Kansas Department of Agriculture
 Division of Water Resources
CHANGE: P/U WORKSHEET

1. File Number: 22576-D2	2. Status Change Date:	3. Change Num: C5	4. Field Office: 4	5. GMD: 3
------------------------------------	------------------------	-----------------------------	------------------------------	---------------------

APPLICATION FOR CHANGE IN PLACE OF USE
 WATER RIGHT, FILE NOS. 16157, 20890, 22576-D3, 22576-DA, 22576-DB,
 22576-D2, 22577-D1, 22578-D2, 24050, 28620, 29855-D1, 30157

RE: Applications for Change in Place of Use
Water Right, File Nos. 16157, 19820-D8, 20890, 22576-D2, 22576-D3, 22576-DA,
22576-DB, 22577-D1, 22578-D2, 24050, 28620, 29855-D1, 29855-D2 & 30157

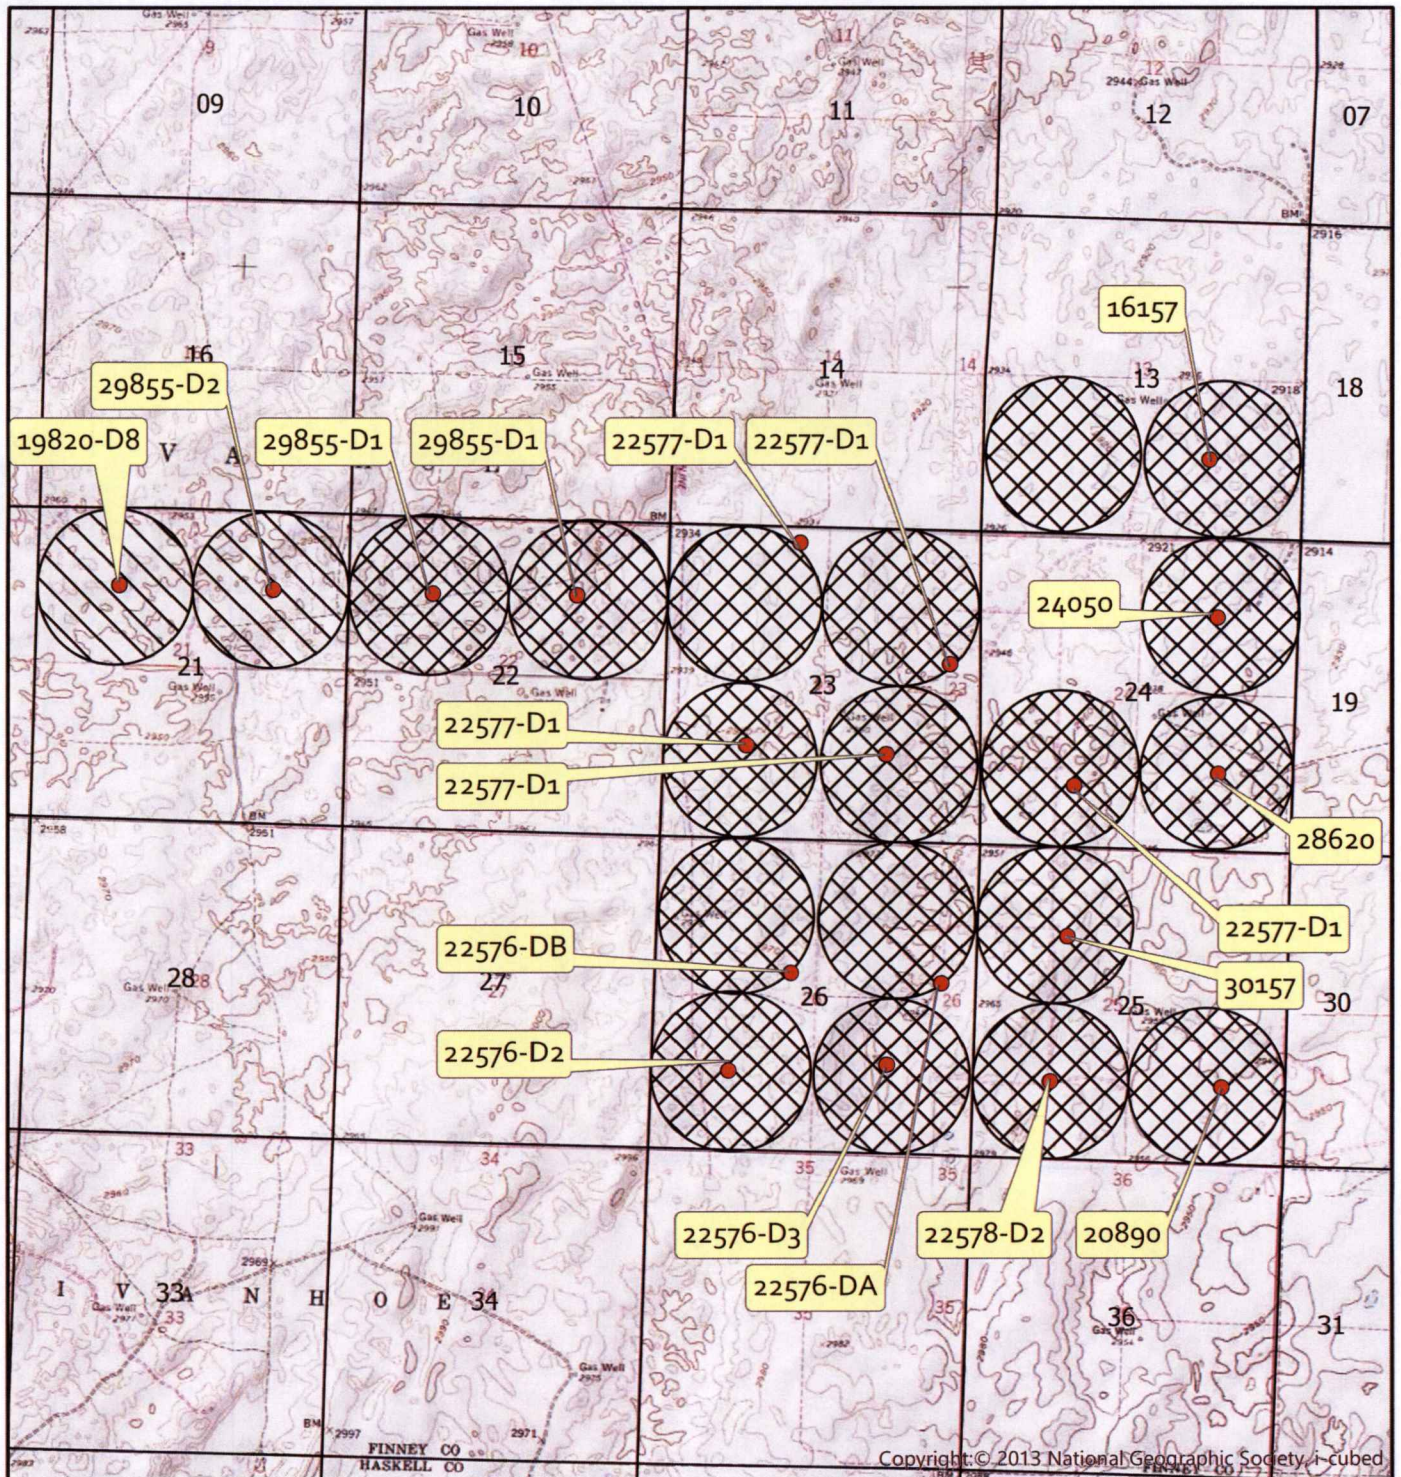
Recommendation: After review of all available information, it appears that the current area rules are met. No new acres, just making a complete overlap in PU. Staff therefore recommends approval of the applications.

Adding PU for
19820D8 & 29855D2

All others are
Currently overlapped
